ITEM FOR ENVIRONMENTAL BOARD AGENDA

**ENVIRONMENTAL BOARD BRIEFING ON
ZONING CHANGE FOR TERRACE PUD**

CASE: C814-86-009.12

PROJECT NAME: Terrace PUD (Revision 12)

PROPOSED REVISION 12

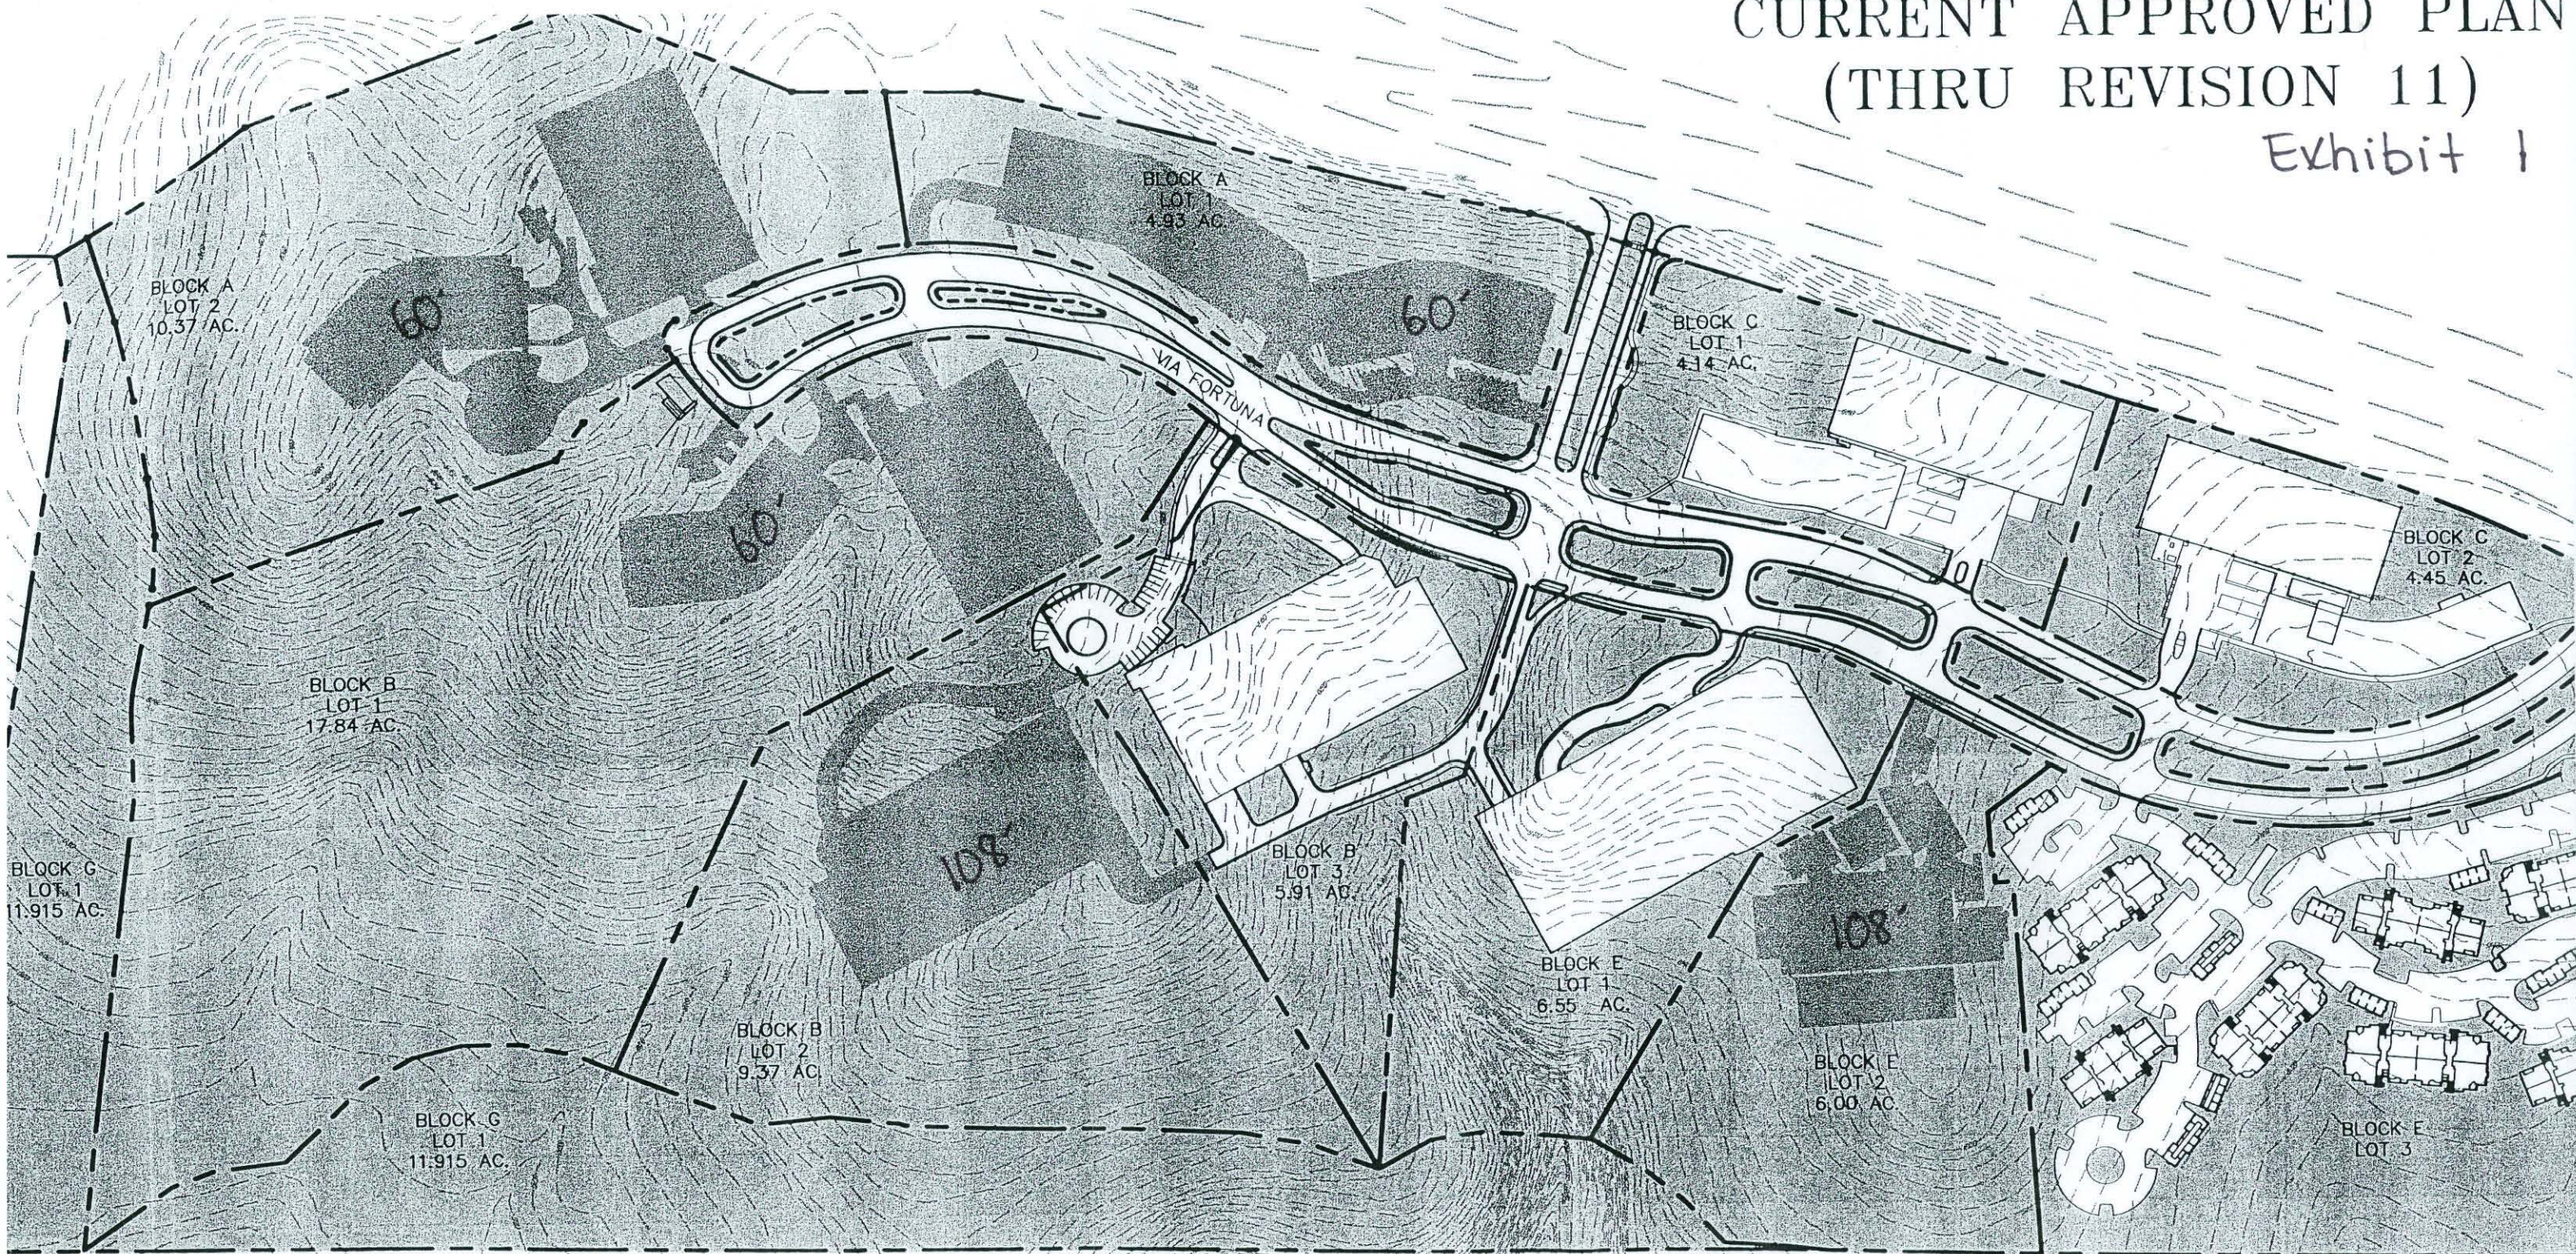
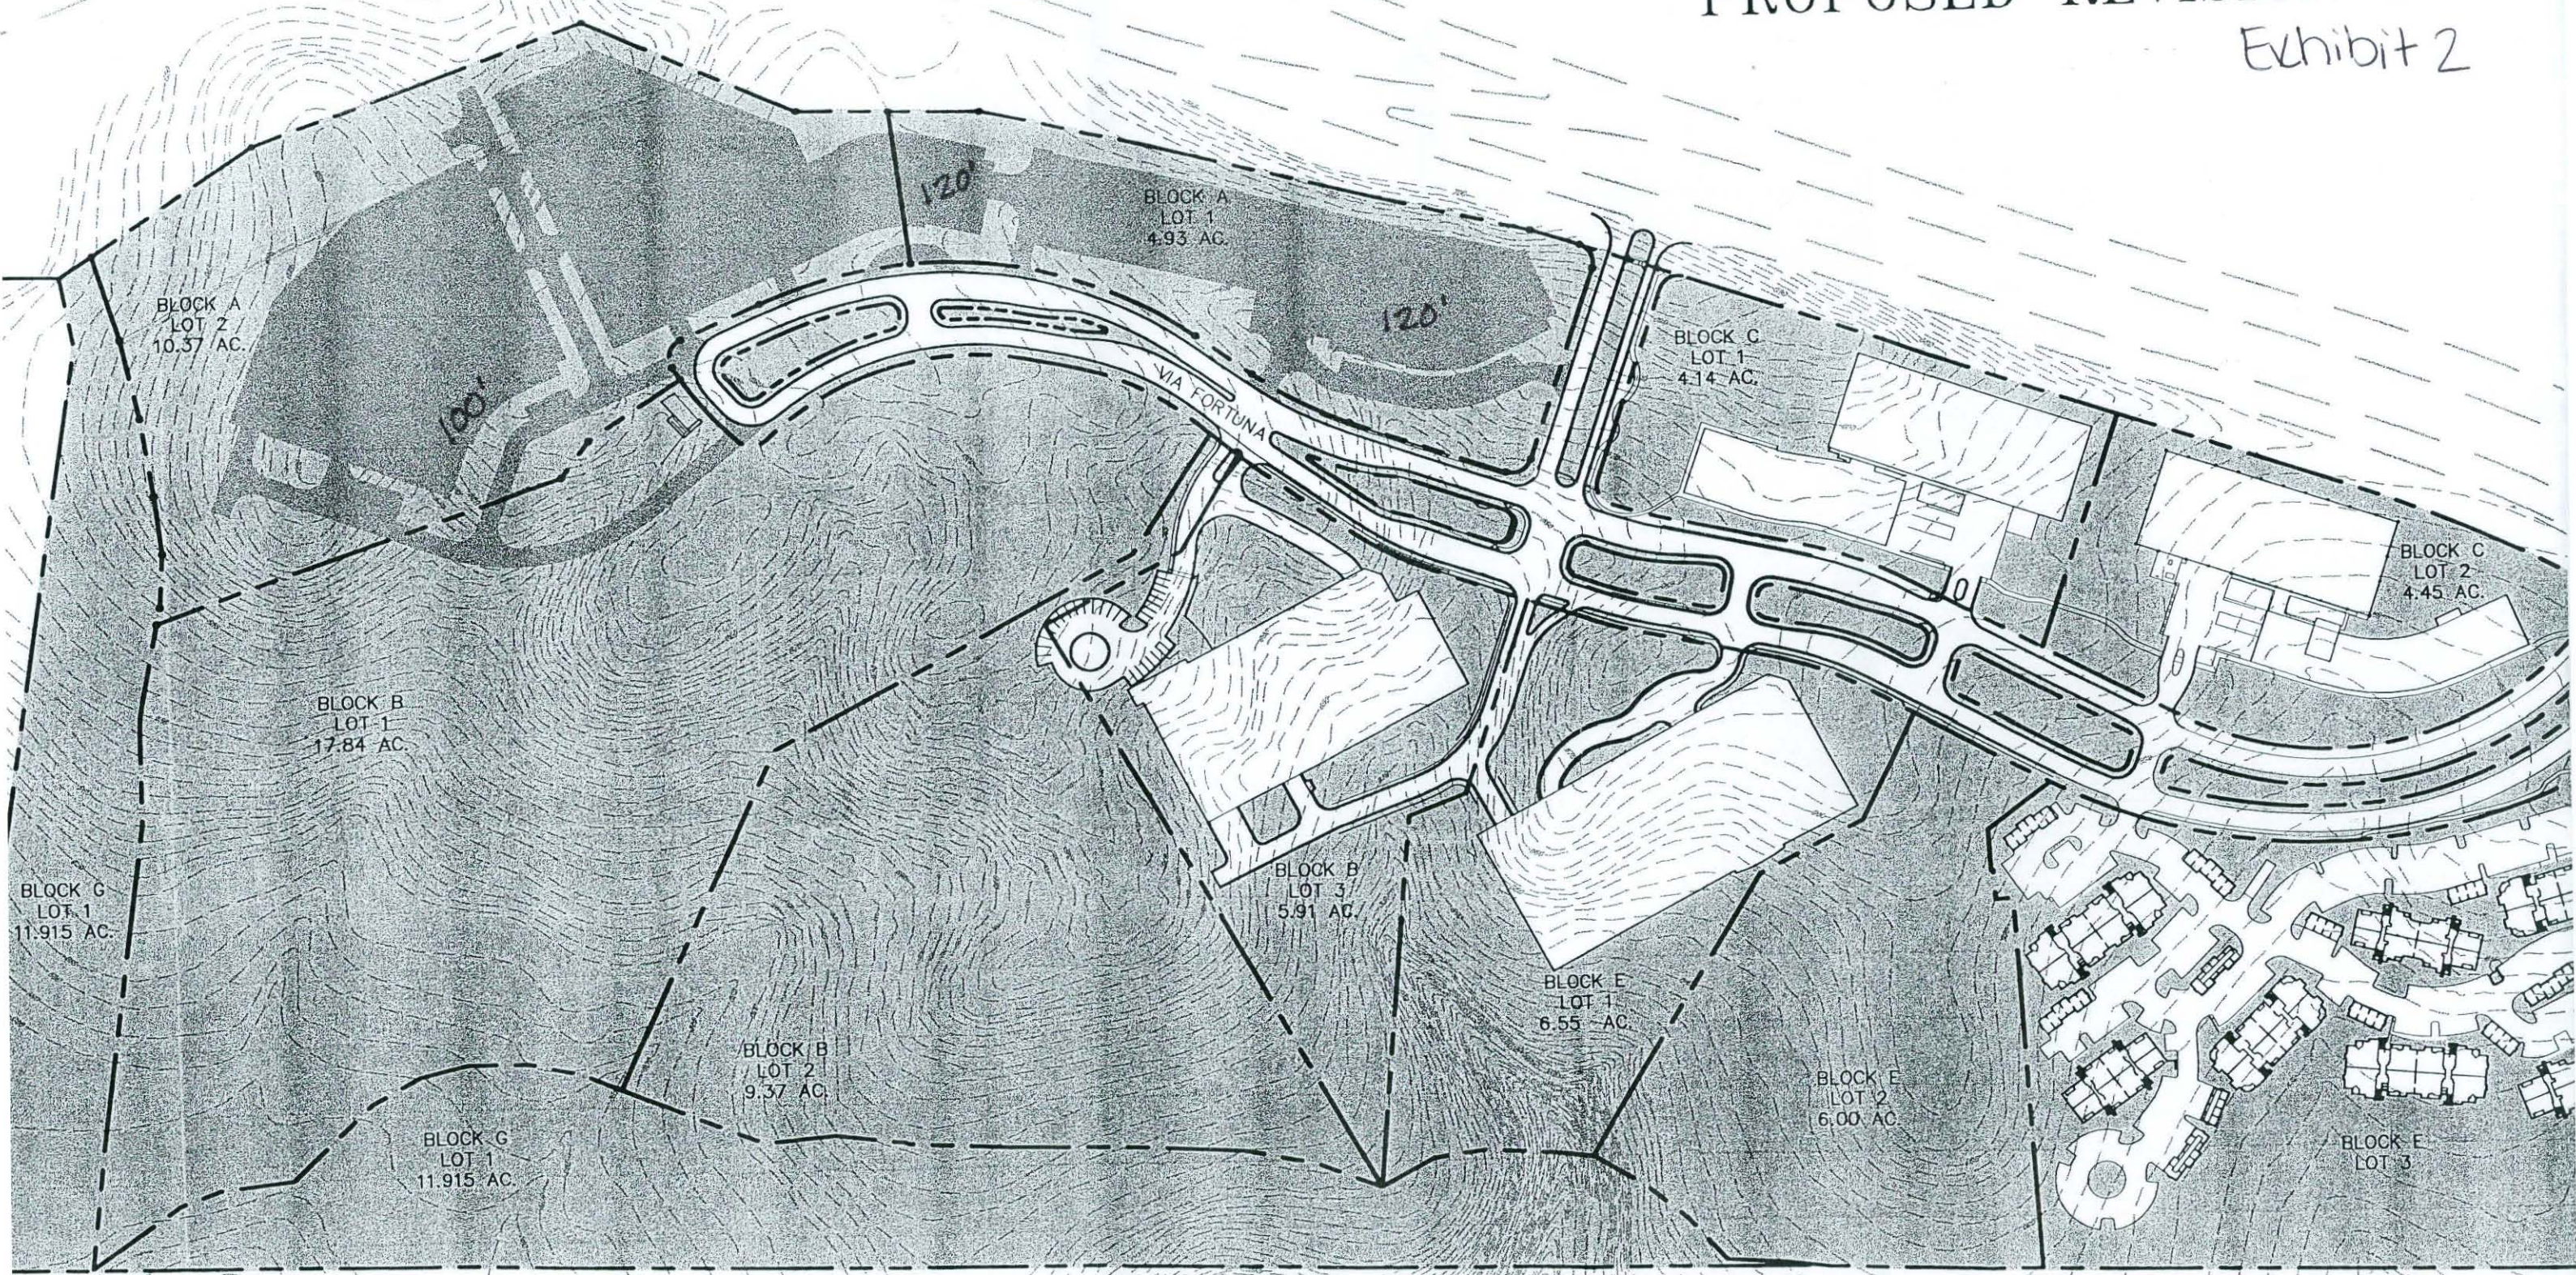
The applicant is proposing to amend a PUD and associated zoning/site plan and restrictive covenant. A PUD zoning district approved under regulations applicable before December 15, 1988 is governed by the previous regulations and shall be identified on the zoning map as a PUD district. The PUD was originally submitted in 1985 and included a Land Use Element (site plan); the PUD was approved in 1987. The PUD site plan layout consists of setbacks, impervious coverage, Floor-to-Area ratio (FAR), height, parking, buffer zones and undisturbed area. The current PUD site plan (shown as Exhibit 1) and the proposed amendment (Exhibit 2) includes removing 4 buildings/garages closest to Barton Creek/neighborhood, and replaces the square footage in the buildings closest to Loop 360 and Mopac. This is accomplished by increasing the height (from 60'-108' to 100'-120') and square footage of the buildings closest to the highways. This revision will decrease the impervious coverage to approximately 28.34% for the site. The proposed amendment is consistent with the assumptions in the March 2006 Traffic Impact Analysis (TIA). The proposed buildings will be office use only and delete restaurant (high-turnover) and retail uses for a decrease in trip generation. The updated values for this revision are presented below:

Parameter	Original Approved PUD	Current Approved Plan	Revision 12
Impervious Coverage (ac)	35.33	32.31	30.96
Downstream Buffer (ac)	38.70	39.10	44.81
Total Sq. Ft.	1,373,100	1,350,333	1,350,333
FAR	.289	.284	.284
Undisturbed Area (ac)	64.10	61.08	65.80

The applicant has agreed the new buildings will be either Silver LEED or Austin Energy Green Builder, a minimum of 2 star rating. Also, the site plan will be revised to maintain the 100 ft. Hill Country buffer from the property line along Loop 360. The applicant has also agreed to provide an Integrated Pest Management Plan for the remaining undeveloped tracts.

1. Silver LEED or Austin Energy Green Builder (minimum 2 star) for the proposed buildings
2. The area extending 100 feet into the site of Loop 360 right-of-way will be maintain and restored to the natural Hill Country character by complying with Austin Hill Country Roadway ordinance for this area.
3. An Integrated Pest Management Plan will be provided for the site.
4. Water quality capture volume will be 1" for all buildings.
